**MACKENZIE PARK**  
**ACCESSIBILITY SURVEY**

**February, 2006**

**CITY OF SANTA**  
**BARBARA**

*Public Right-of-Way - Photo # 1*

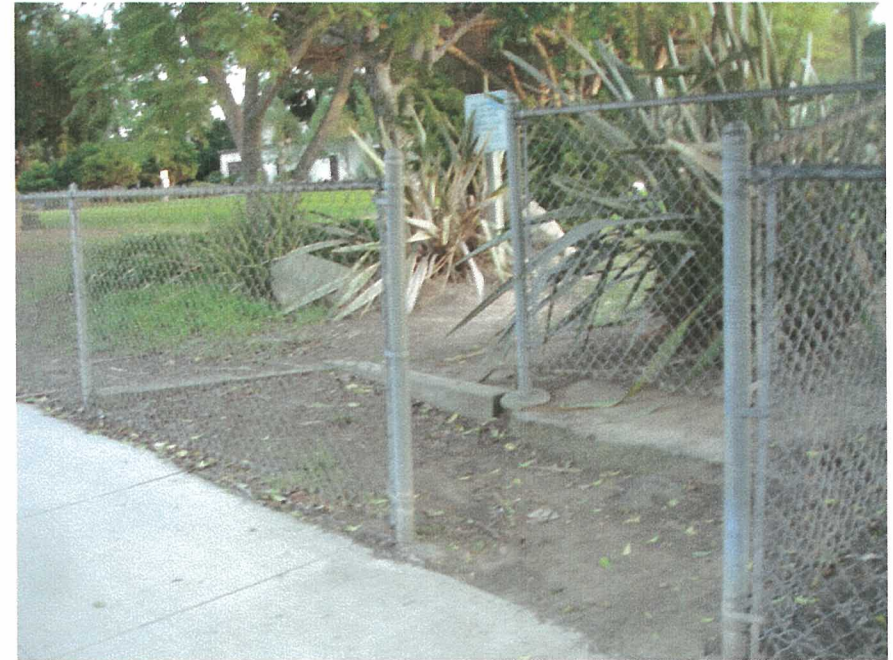
*There are no detectable warnings at curb ramp. Curb ramp does not have contrasting color with adjacent surfaces. Top landing is 40" instead of the required 48" deep.*

*Public Right-of-Way - Photo # 2*

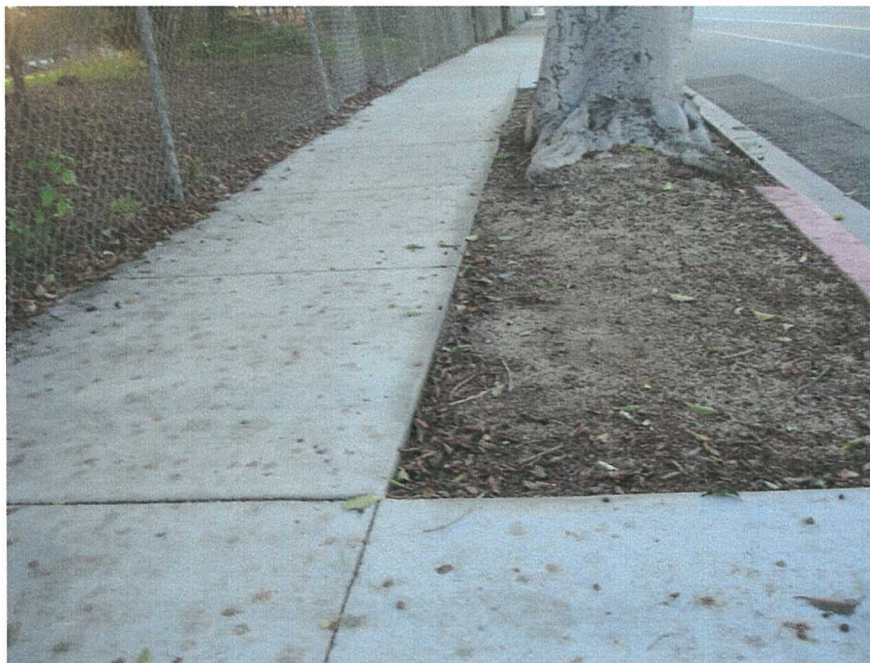
*Gate path of travel is not accessible, surface is not firm, and stable. There is a step that makes this entrance inaccessible to wheelchair users.*

*Public Right-of-Way - Photo # 3*

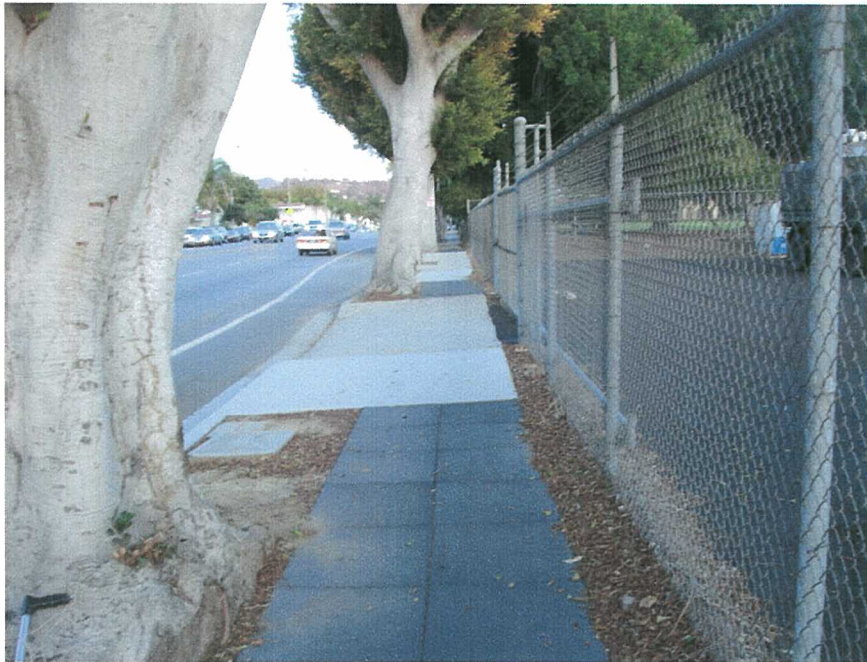
*Tree well has 1" drop at several locations. Maintenance of dirt or bark is needed to avoid drops that can be a tripping hazard to pedestrians.*

*Public Right-of-Way - Photo # 5*

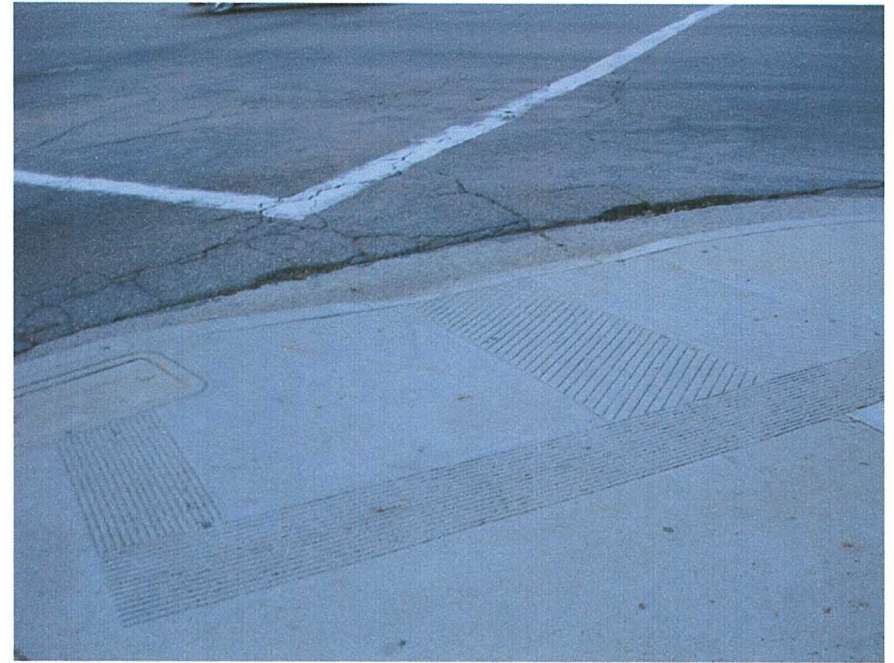
*There are excessive cross slopes that range from 2.8%  
- 6.3%.*

Site - Photo # 3

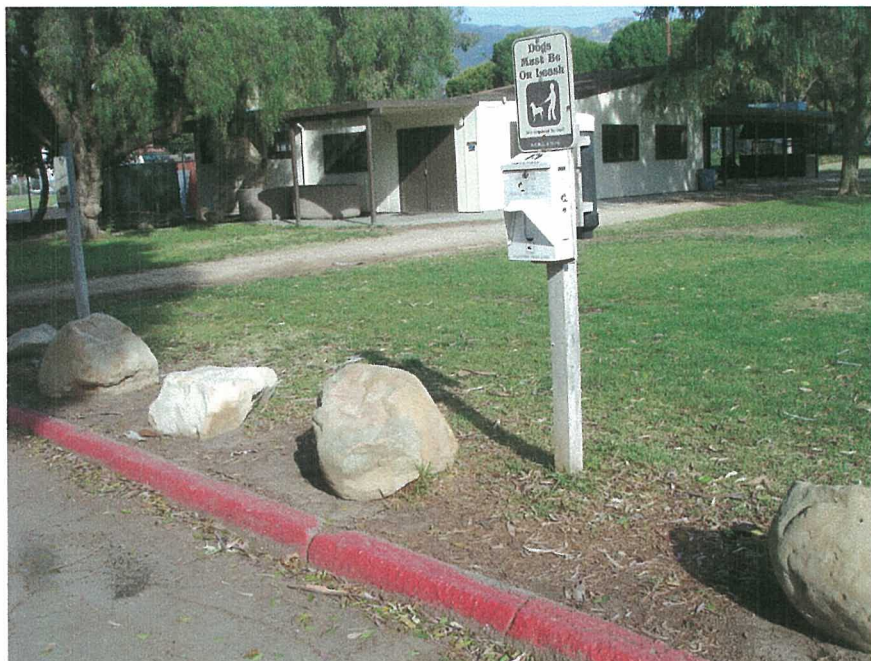
*Path of travel from accessible parking stalls to children's playground and Adult Center – Building E is not accessible, grass is not considered a firm, stable and slip resistant surface.*

*Site - Photo # 11*

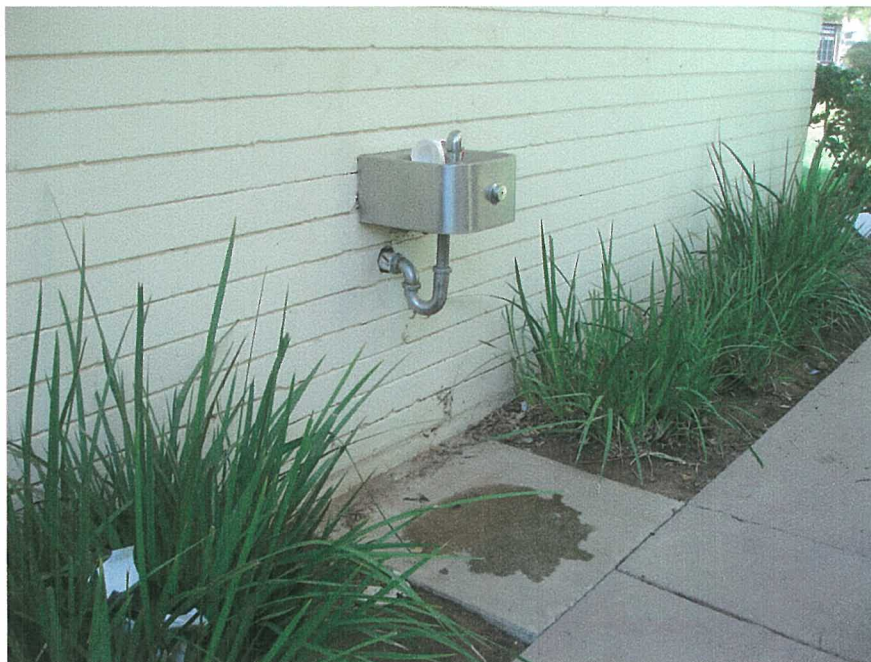
*Path of travel to bleachers is not firm stable and slip resistant.*

Site - Photo # 22

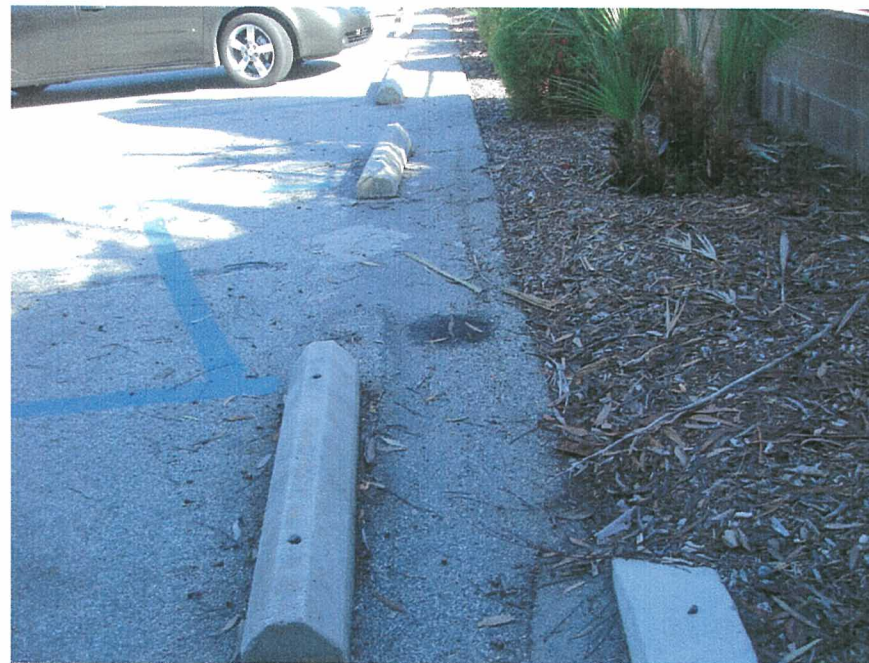
*Stair is 36" wide, risers 6" with the exception of the bottom riser 3 1/2" high. Non-compliant handrail extensions, contrasting color not 70% contrast. Debris accumulated on risers.*

*Building - Photo # 6*

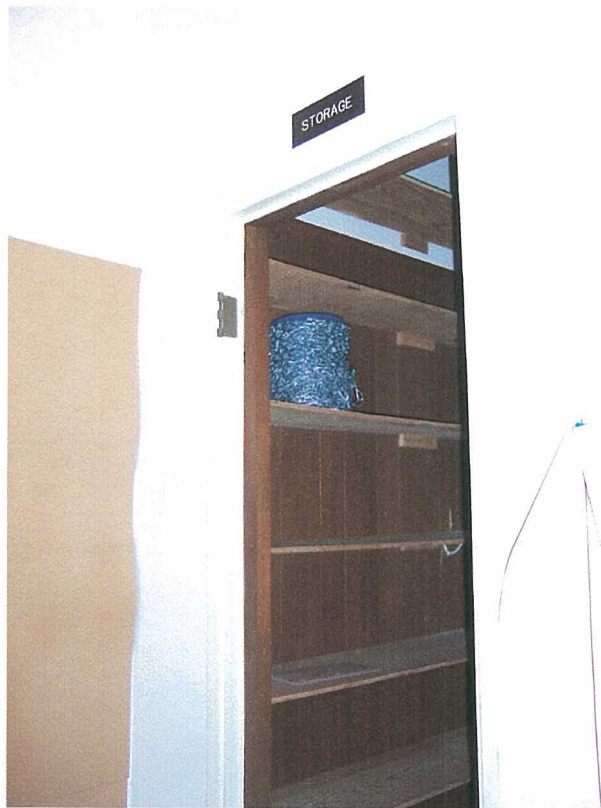
*There are not tactile and Braille "EXIT" and room identification signs. Door hardware requires tight grasping to operate.*

*Building - Photo # 9*

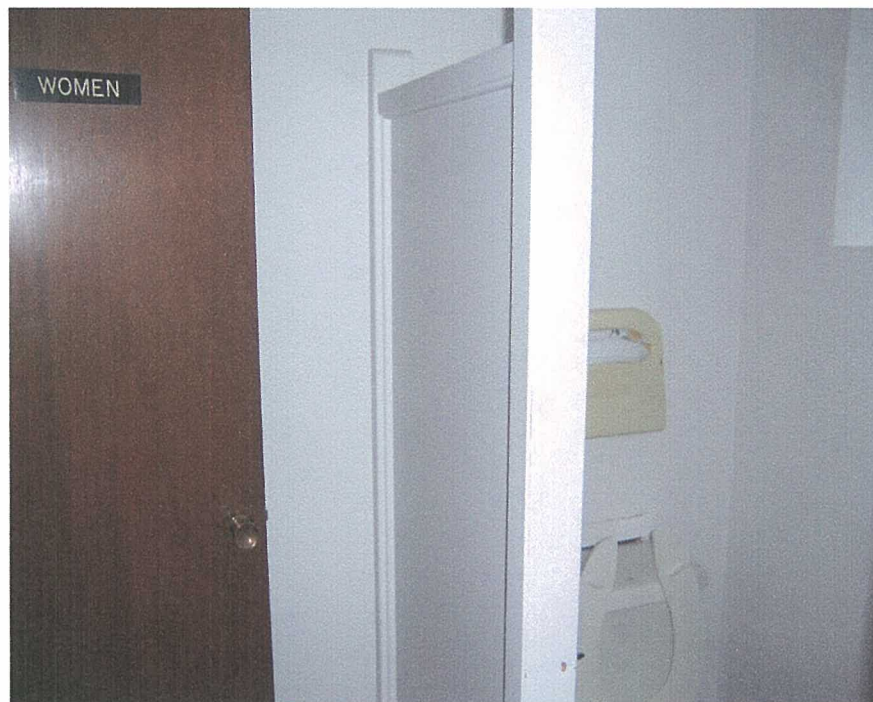
*Cased opening is 22 ½" wide – not wheelchair accessible. There is no tactile and Braille room identification sign.*

*Building - Photo # 2*

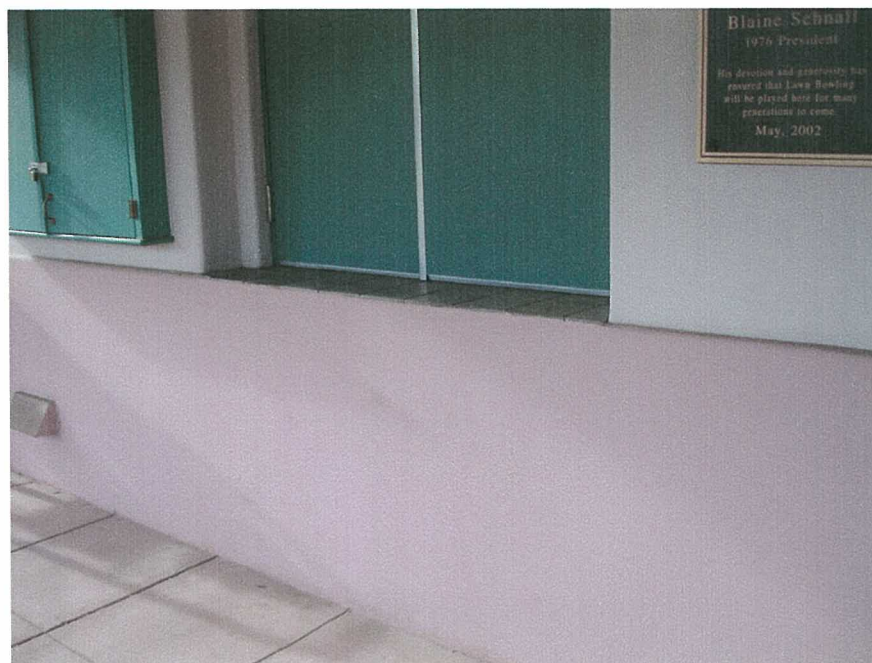
*There is no tactile and Braille "EXIT" sign. Bulletin board lower edge is mounted at 43" high.*

*Building - Photo # 4*

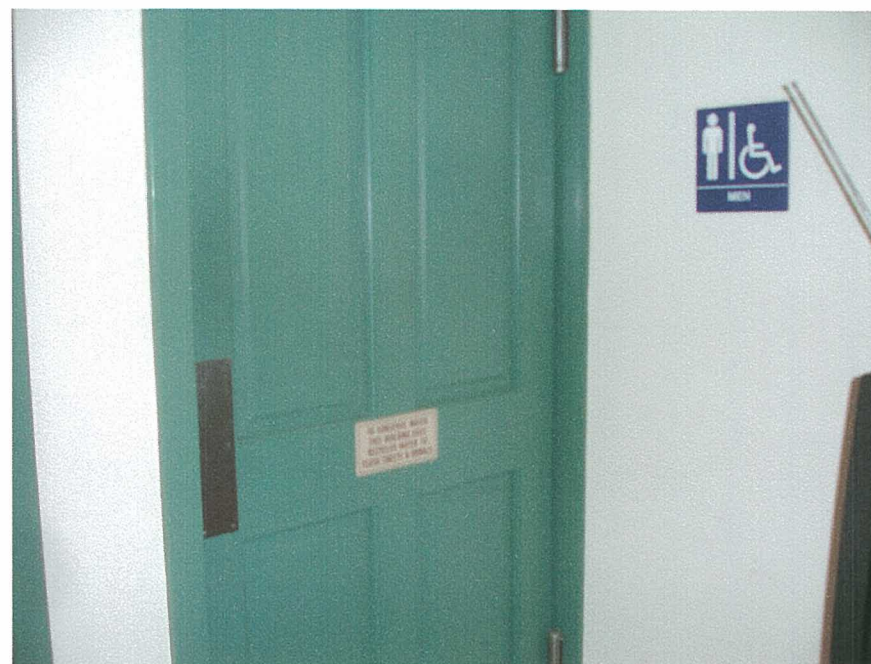
*Loose doormat needs to be secured. Doorstop mounted at lower 10" kick plate area is not compliant, this area is required to be smooth.*

*Building - Photo # 6*

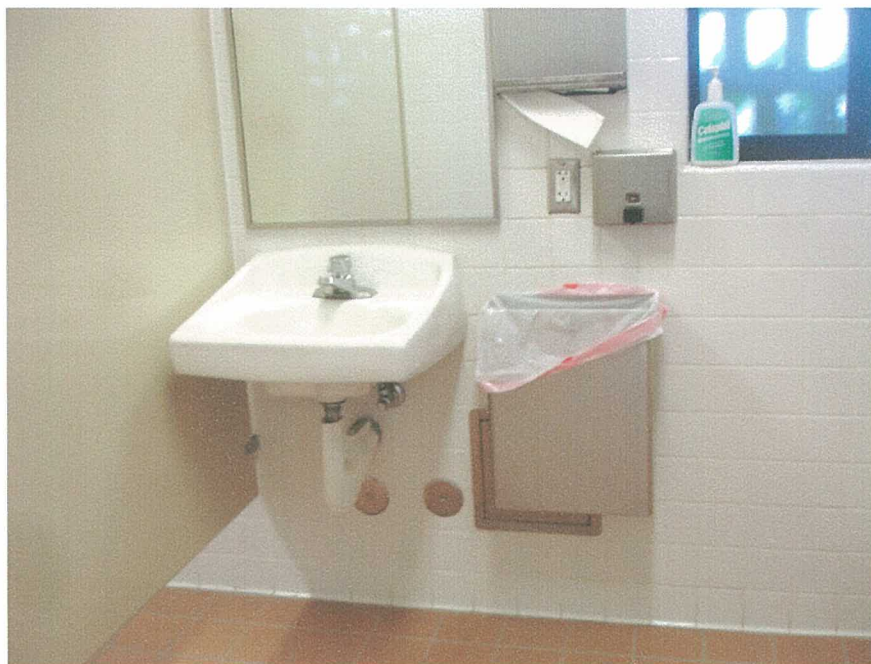
*There is not a triangular California required sign mounted at the door.*

*Building - Photo # 8*

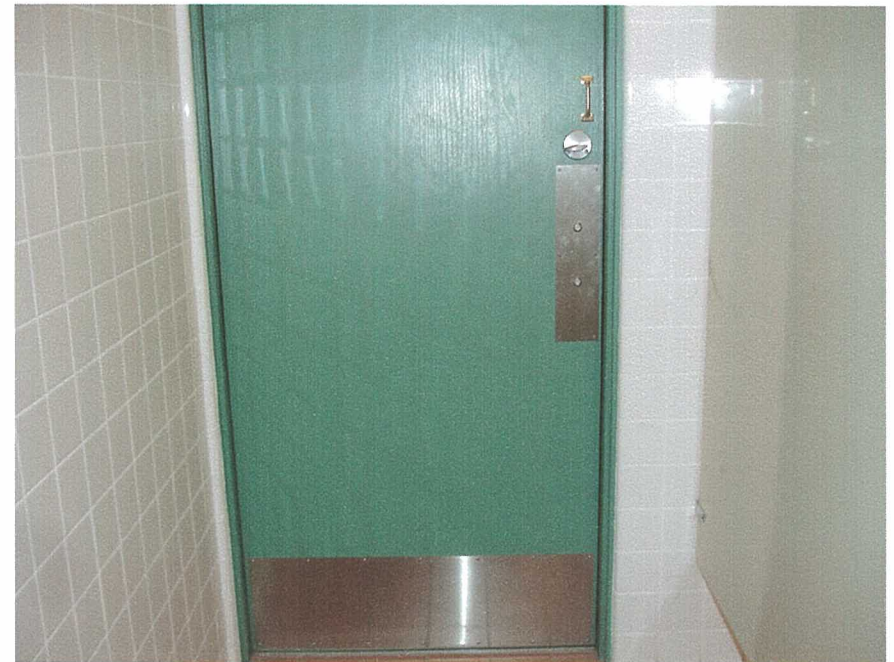
*There is no "U-pull" at interior accessible water closet compartment door. Toilet paper dispenser is mounted to close to grab bar.*

Toilet stall hardware.	Toilet stall doors shall have accessible door hardware at both sides of door.	No U-pull inside of door. Photo #: 8	ADAAG: 4.17.5  T24: 1115B.7.1.4	Provide accessible stall door hardware on interior and exterior.	1	JOB	\$150	\$150	2

*Building - Photo # 11*

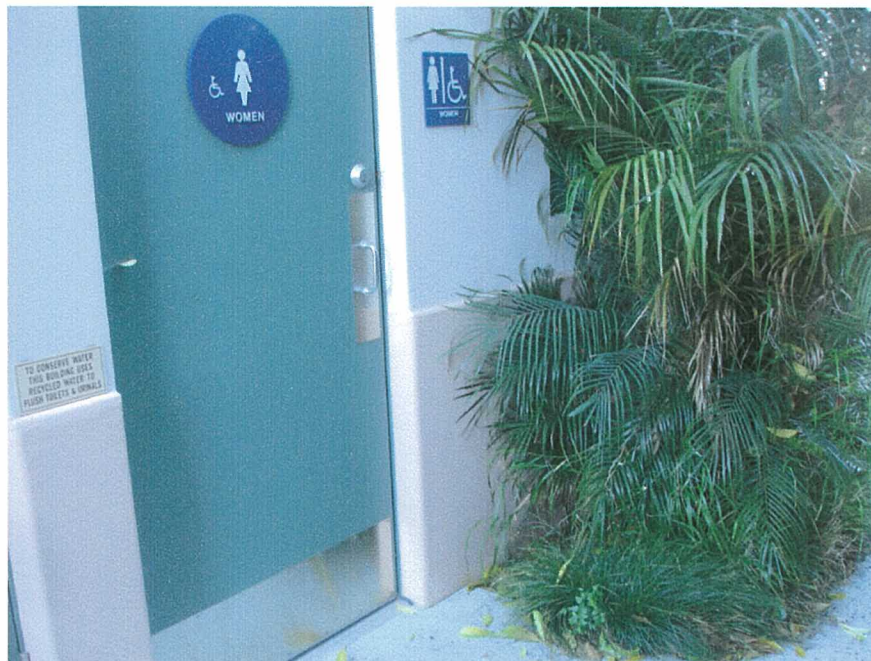
*Room identification tactile and Braille sign is missing.*

*Building - Photo # 13*

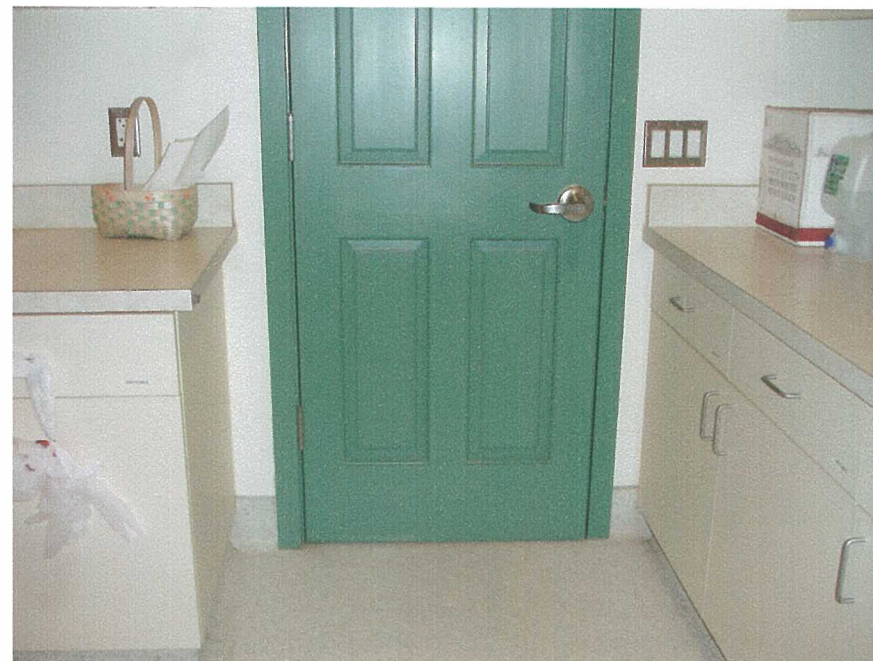
*7" exterior door strike side clearance due to the location of planter, instead of the required 24" minimum.*

*Building - Photo # 18*

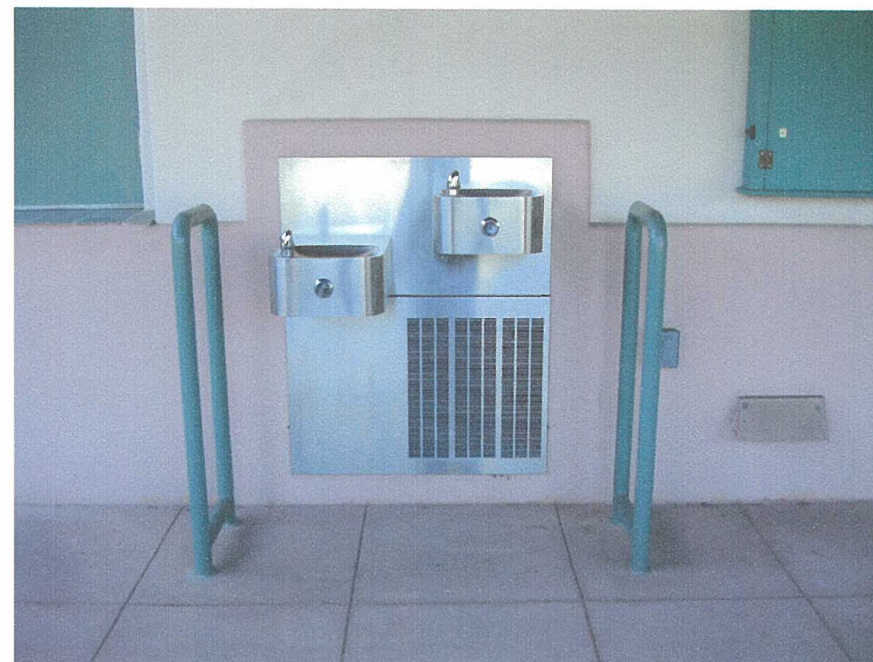
*Door strike side clearance at the pull side of door is 5 ½" instead of the required 18" minimum. Door is too narrow – 27" wide and not wheelchair accessible.*

*Building - Photo # 1*

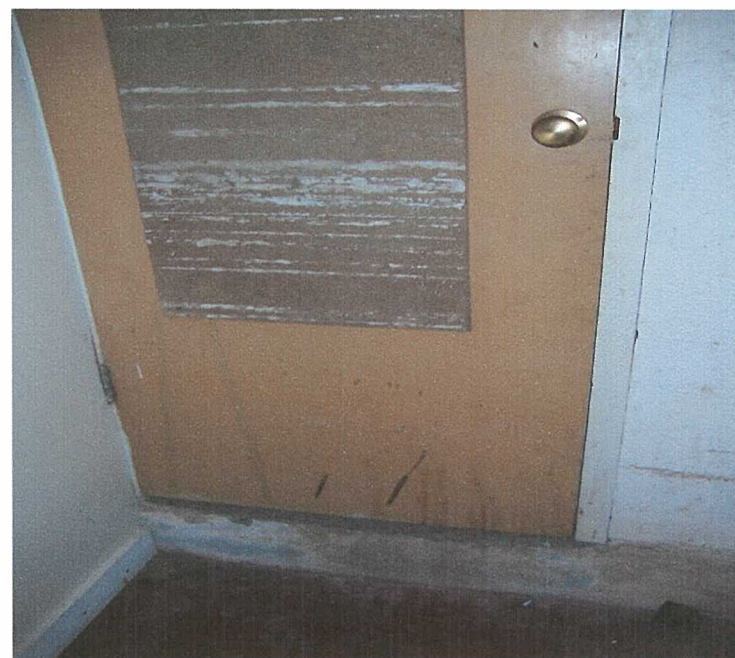
*Door hardware requires tight grasping to operate and twisting of the wrist to operate. Threshold is 1" high instead of ½" beveled maximum. There is 36" to the wall in front of the door and 0" strike clearance on the pull side of door. A recommendation is to change the door swing.*

*Building - Photo # 3*

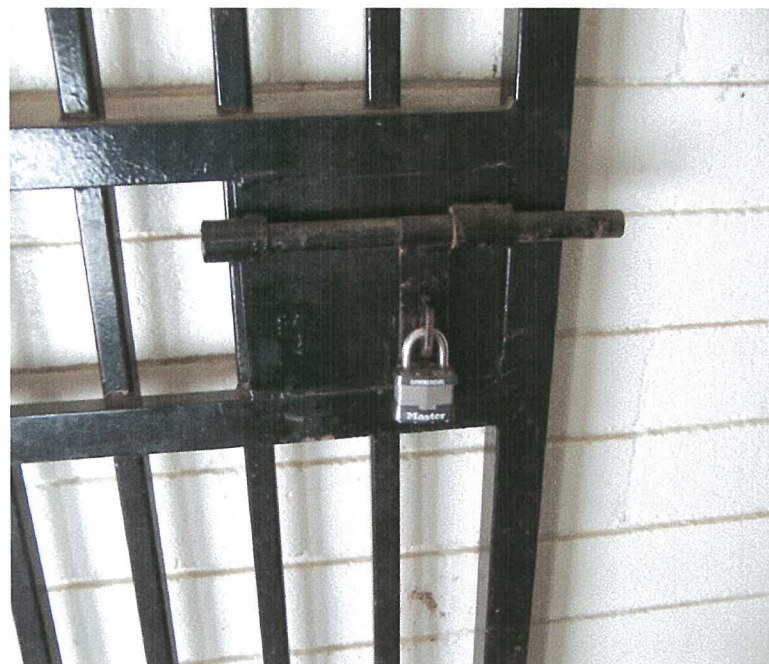
*Door does not have tactile and Braille room identification sign.*

*Building - Photo # 6*

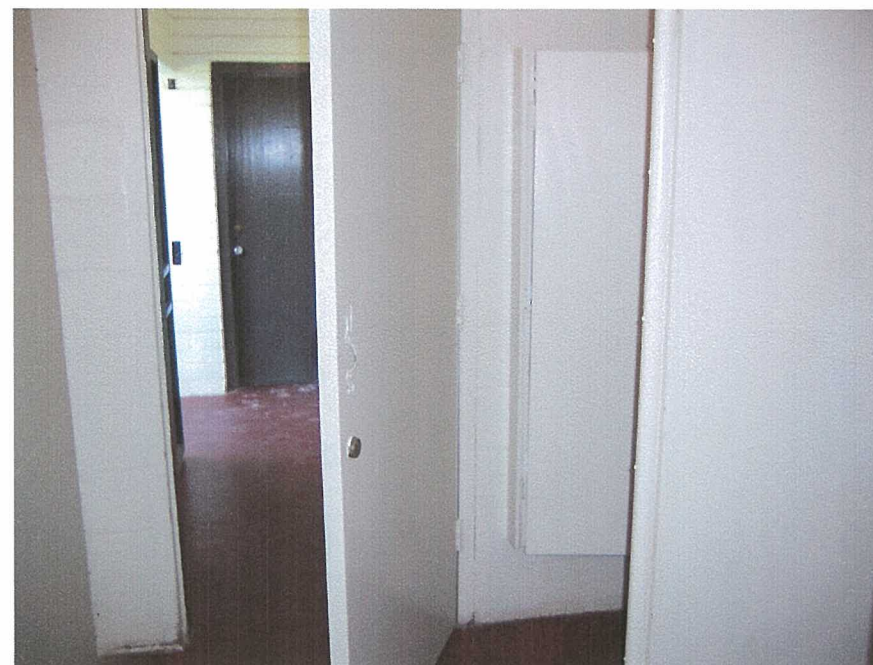
*Gate at Men's restroom does not have the required kick plate and accessible door hardware. There is no compliant restroom tactile and Braille signage as well as the triangle door sign required in California.*
